**COMMUNITY SERVICES DEPARTMENT**

**Subject: Lorson Ranch Sketch Plan Amendment No. 2 (SKP-19-001)**

<b>Name:</b>	Lorson Ranch East Filing No. 3 Final Plat	<b>Application Type:</b>	Final Plat
<b>PCD Reference #:</b>	SF-193	<b>Total Acreage:</b>	19.50
		<b>Total # of Dwelling Units:</b>	81
<b>Applicant / Owner:</b>	<b>Owner's Representative:</b>	<b>Dwelling Units Per 2.5 Acres:</b>	10.39
Lorson, LLC	Lorson, LLC	<b>Regional Park Area:</b>	4
Jeff Mark	Jeff Mark	<b>Urban Park Area:</b>	4
212 N. Wahsatch Avenue, Suite 301	212 N. Wahsatch Avenue, Suite 301	<b>Existing Zoning Code:</b>	PUD
Colorado Springs, CO 80903	Colorado Springs, CO 80903	<b>Proposed Zoning Code:</b>	PUD

**Lorson Ranch Filing No. 3  
 Final Plat**

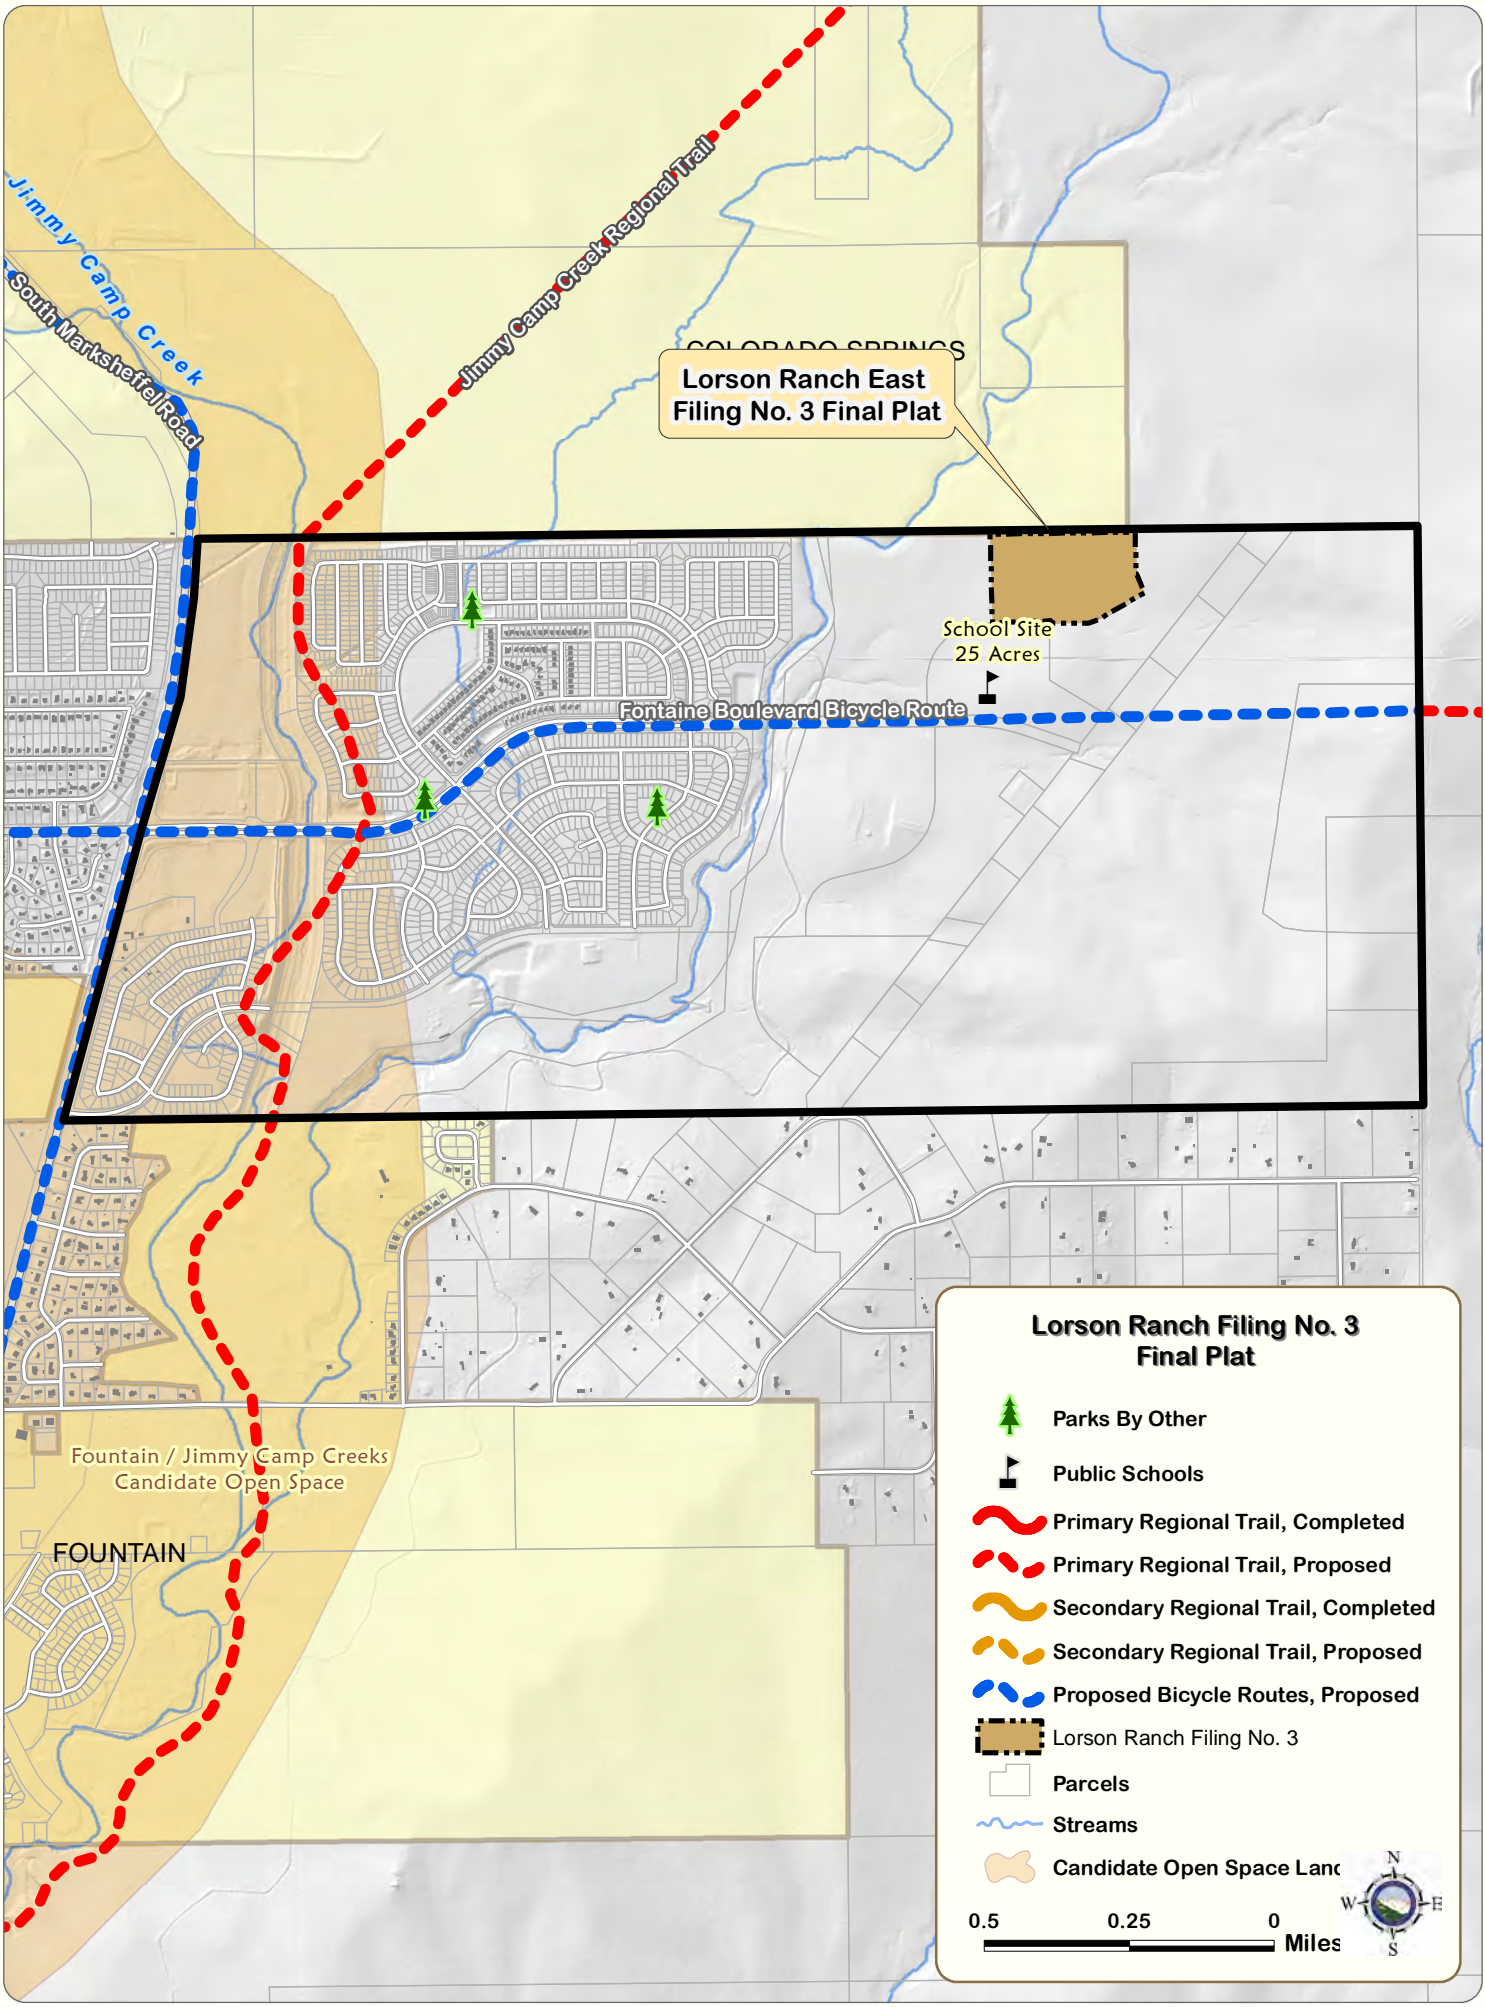
The County Parks Master Plan shows the Fontaine Boulevard Bicycle Route south of the Filing No. 3 project area along Fontaine Boulevard. This bicycle route will be accommodated within County right-of-way and installed as part of future road improvements. There are no County regional trails within Filing No. 3; however non-County trails were shown on the previously approved PUD and Preliminary Plan drawings which Filing No. 3 is contained within. The Filing No. 3 final plat drawings are missing previously included non-County trails shown on the approved PUD and Preliminary Plan drawings. This includes a trail along the northern boundary within Tract A. Please show the non-County trails on the final plat drawings.

*Recommend to the Planning Commission and Board of County Commissioners that approval of Lorson Ranch East Filing No. 3 Final Plat include the following conditions: (1) Show non-County trails within Tract A on the final plat drawings consistent with the previously approved PUD Development and Preliminary plan (2) require fees in lieu of land for regional purposes in the amount of \$36,936 and urban fees in the amount of \$23,328. A park lands agreement may be an acceptable alternative to urban park fees provided the agreement is approved by the County and executed prior to recording the final plat.*
